Transpower's HVDC Stage 1 major capex project proposal

Draft decision – Attachments A to D

1 April 2026

Figure D1 AHI estimates for HVDC cable 4

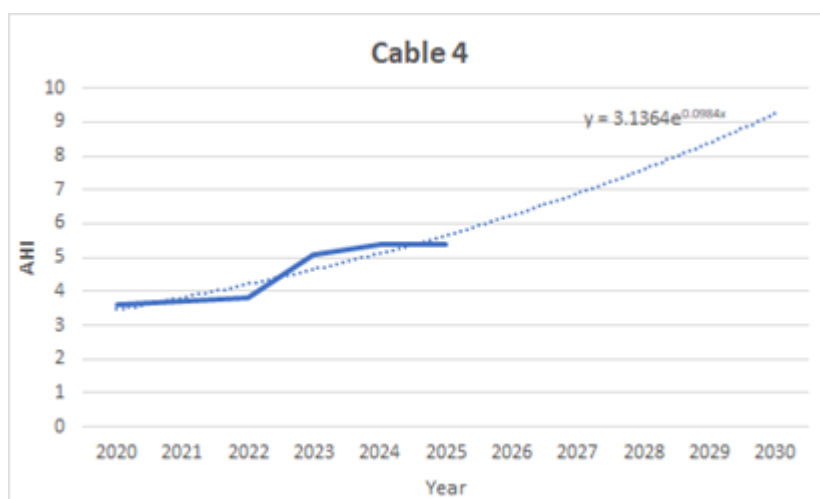
D29 Our analysis projected forward the asset health indicator data presented in Transpower’s cable condition assessment report to test whether an AHI of 8 or above corresponded to the Transpower replacement need dates.

D30 Figure D.1 presents AHI results for cable 4 and shows that an AHI of 8 is likely to occur around 2030, a trigger for cable replacement, and confirmation of the Transpower replacement decision.

D31 While the decision to replace the cables by the early 2030s is a model-driven risk-based decision, Transpower notes that it has already had to repair a cable fault in 2004. A ground fault was detected 345m from the cable sealing end at Oteranga Bay and repaired. Even though the fault occurred close to the Oteranga Bay termination, it still took 6 months before the repair was completed.
